Reviewer 3

This study presents a global inventory of lake-terminating glaciers based on the RGI 7.0 glacier inventory and published datasets of glacial lakes. The key approach involves determining the relationship between glaciers and glacial lakes (direct contact or not) in different cases, considering the ambiguity in the published datasets, which map glaciers/lakes based on images with varying time stamps that may differ by several years or over a decade. The authors adopted a manual interpretation strategy, with clear guidance on different categories of glacier-lake relationships, each implying a different level of confidence on the impact of lake water on glacier dynamics. The manuscript is well-written and logically clear, except for a few instances of inappropriate naming (e.g., lake-level) and ambiguous implementation of different classifications. I believe that this dataset with consistent quality control benefits future investigation and modelling of glacier dynamics (velocity changes, mass balance) in response to climate warming.

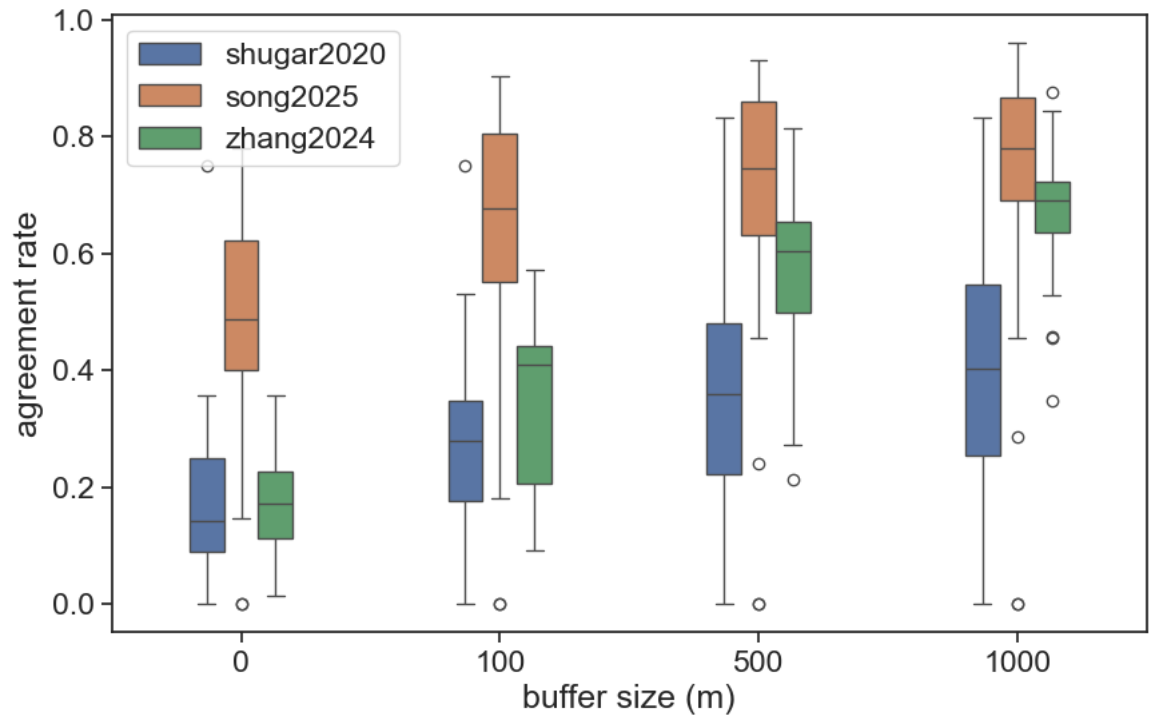
My main concern lies in the ambiguous definition of lake-terminating glaciers and how the current classification represents in the temporal span. If the lake-terminating glaciers refer to glacier terminuses that are in direct contact with glacial lake water, then the manual inspection is to rule out glaciers with supraglacial lakes and glacial lakes surrounding glaciers in the lateral zones. However, Figure 2d (lake-level 2) appears to include glaciers that are not directly in contact with the glacier terminus. It seems that lake-level 3 are not regarded as lake-terminating glaciers in the results and analysis (Line 135-137). In addition, it is also interesting to see how the data products of this study differ from a simple classification method, e.g., flagging lake-terminating glaciers by simply overlapping the buffering of glacier outlines with lake outlines. Such a comparison can help understand how the expert inspections implemented in this study improve the classifications.

- d) While applying a buffer is easily done, adding 100 m around glacier termini increases the number of glaciers intersecting with lakes considerably in most regions (Table 1) but there is no way of telling whether 100 m is adequate at a global scale. We can show that when the buffer is increased, we find a much larger agreement rate (Figure 1), but also false positives increase rapidly (Figure 4), which then puts us back in the situation of having to evaluate manually.

We now suggest to include a more detailed argument for this decision in the Methods section, and provide a number of figures that outline the potential alternative approach with global and regional inventories as an Appendix.
